**ANALYSIS:  
BROADFIELD LANE**

## 11.2 Contractors Drawings of Proposed Replacement Windows

## 11.5 Feedback on Built Pilot Flat

### **Email Correspondence from Nick Baxter**

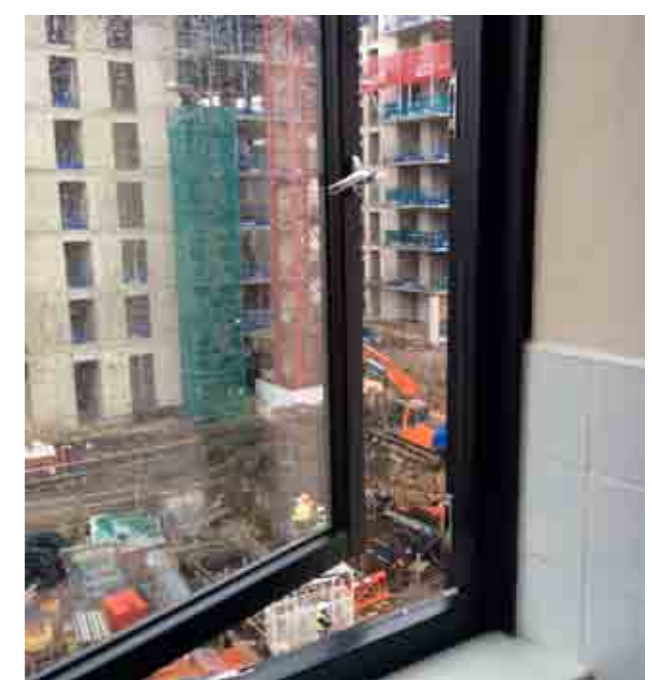
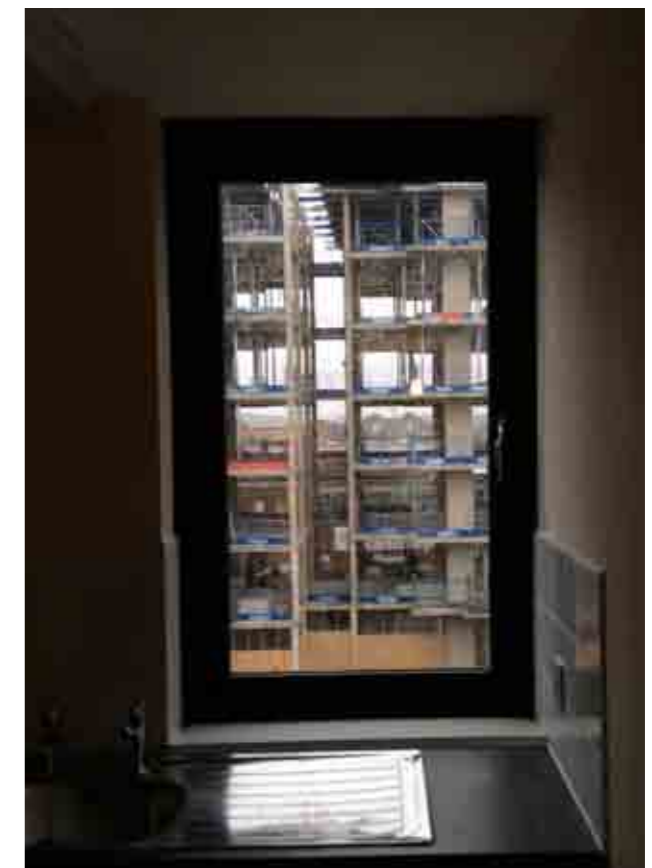
A) We will need reassuring about the trickle vents - firstly, where they must be fitted, they need to match the rest of the window frame and not be brick red. But, secondly, it was not clear to us why two adjacent windows, both of which were openable and neither of which could be climbed through by a burglar, each needed to have a trickle vent. Please minimise these, and make them the right colour.

B) The access-level flats are considerably more complicated and more prominent, and will need further discussion. Do you propose a second show flat? We are uncomfortable with the loss of the frameless corner glazing feature. It did occur to me that, if it is unfeasible to replicate this with double-glazed units, perhaps this small section - or perhaps the entire non-opening part -- of the clerestory could be secondary glazed. This would make the frameless corner a far simpler and cheaper undertaking.
